# AGENDA – City Council Meeting Amended

**CITY OF SARATOGA SPRINGS**
**Tuesday, March 24, 2026 @ 6:00 pm**
City of Saratoga Springs Council Chambers
319 South Saratoga Road, Saratoga Springs, UT 84045

2. Preliminary Plat and Site plan for ASD High School 722. Located approximately at the Northwest corner of Ensign Drive and Mountain View Corridor. Frank Pulley, Alpine School District as applicant.
3. Amendments to Title 19 Land Development Code of the City of Saratoga Springs, chapters 19.02, 19.04, & 19.05 regarding Auto Repair and Car Wash Standards. City Initiated, Citywide. Ordinance 26-10 (03-24-26).
4. Amendments to Title 19 Land Development Code of the City of Saratoga Springs, chapters 19.02 & 19.05 regarding city-owned office trailers. City Initiated, Citywide. Ordinance 26-11 (03-24-26).

# Exhibit 5. Concept Site Plan

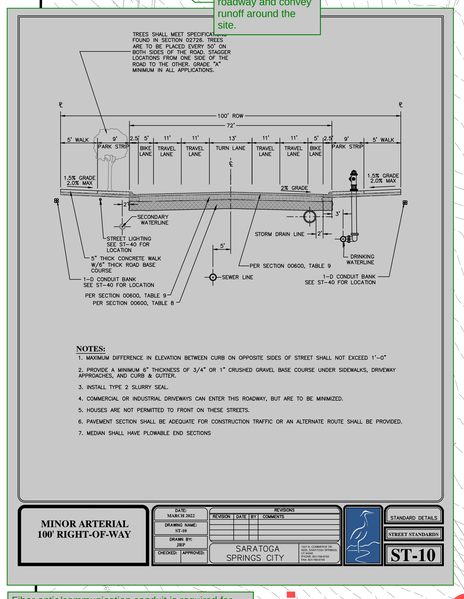
Consider using colors for line work, some of the SD lines blend in with curb lines or other linework.

It is hard to tell, is there a SD line here?

Label valve cover "FIRE"

Identify the separation distance in locations where DW crosses SS

Exhibit 6. Concept Building Elevations

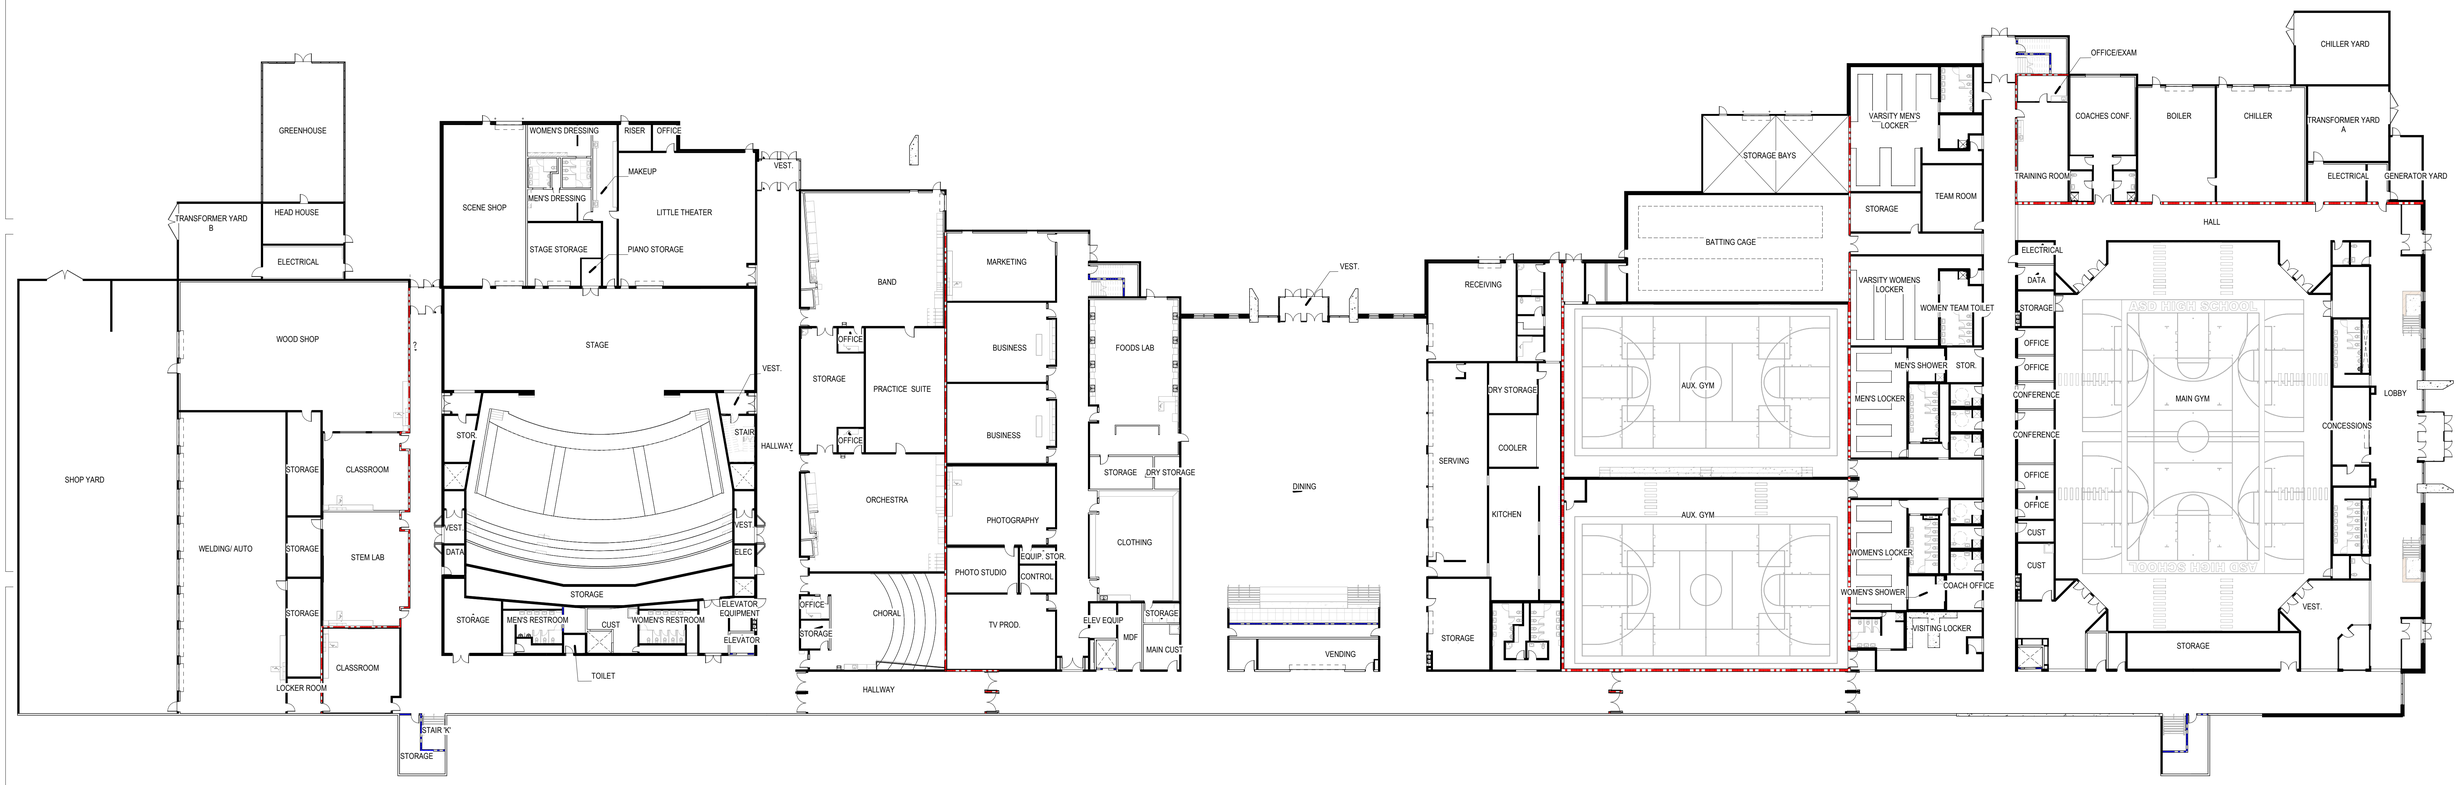
Label the building height from established grade

Provide elevations showing the school from each direction.

# SARATOGA SPRINGS HIGH SCHOOL SUBDIVISION

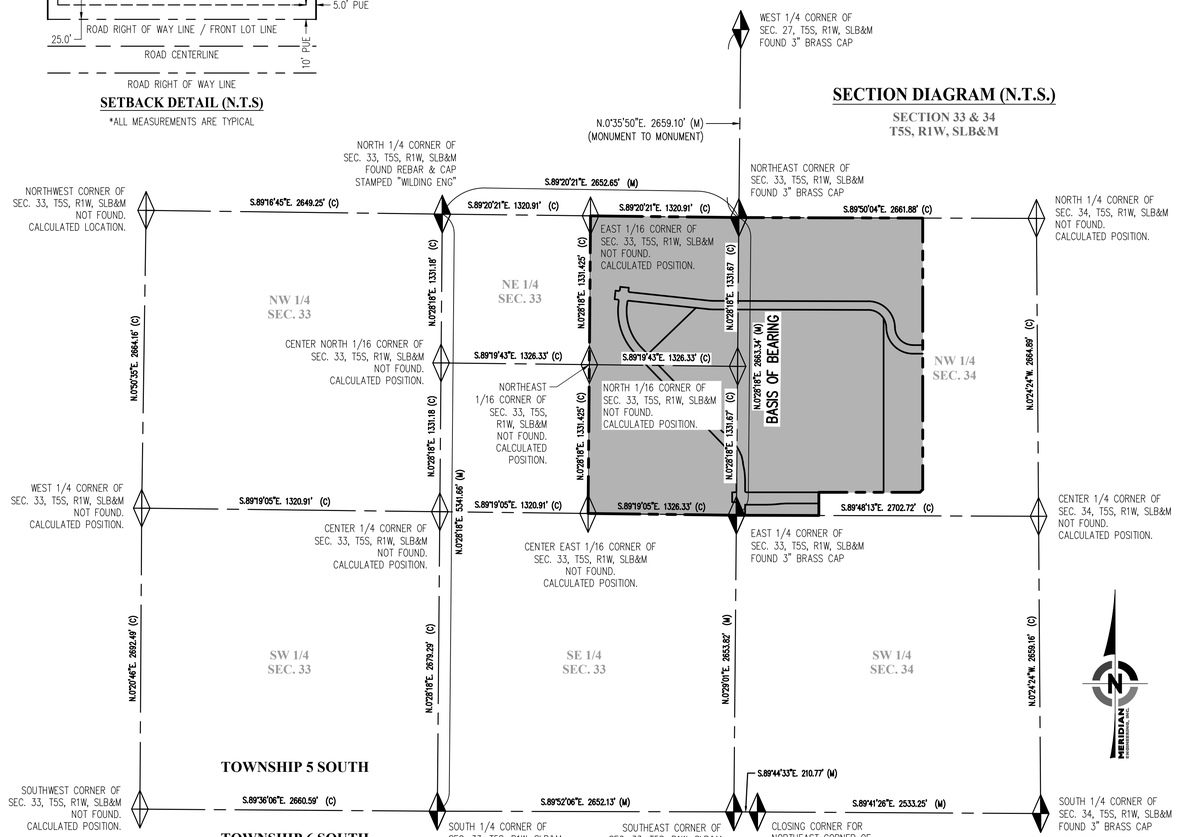
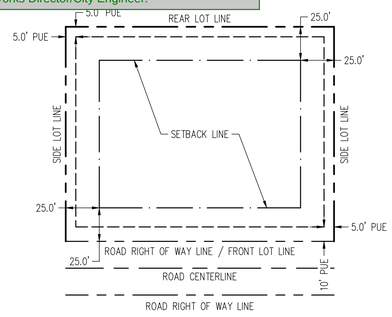
Use Saratoga Springs Standard plat notes. Refer to standard plat template SP-1 in the 2025 Standard Technical Specifications and Drawings.

**SARATOGA SPRINGS HIGH SCHOOL SUBDIVISION**
SITUATED IN THE NORTHEAST QUARTER OF SECTION 33 AND THE NORTHWEST QUARTER OF SECTION 34, TOWNSHIP 5 SOUTH, RANGE 1 WEST, SALT LAKE BASE & MERIDIAN, SARATOGA SPRINGS, UTAH COUNTY, UTAH

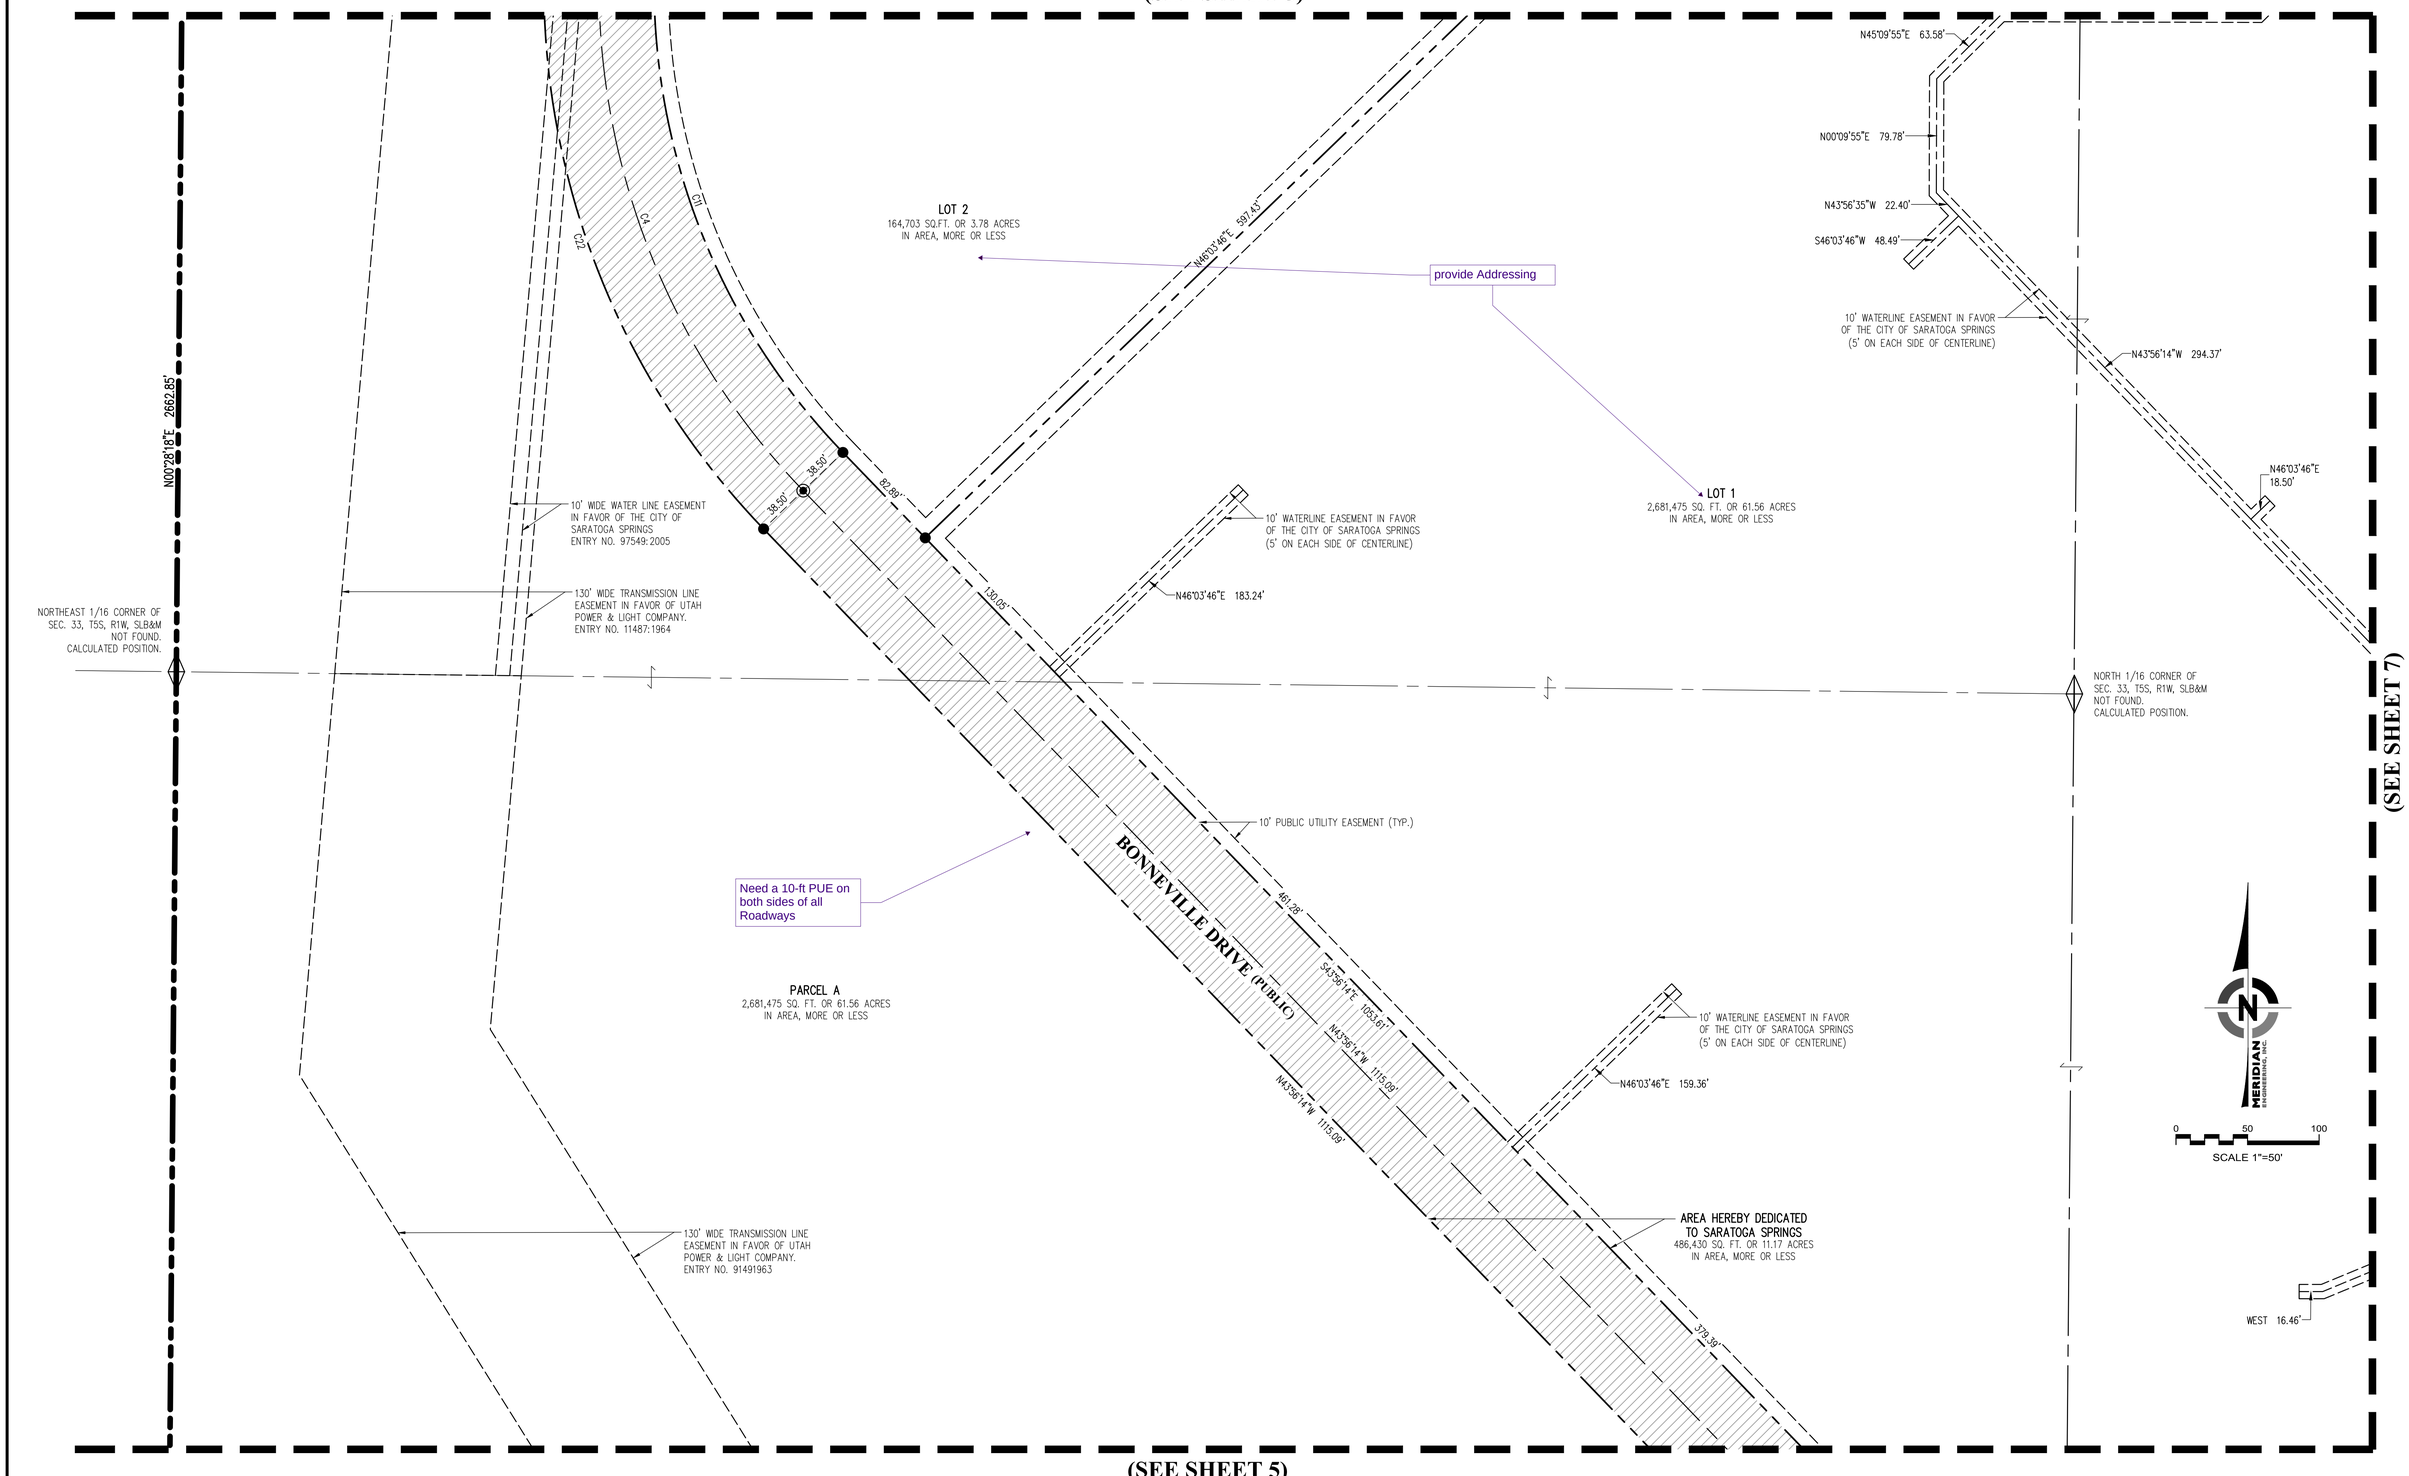
Refer to comment on sheet 2 of this Plat submittal
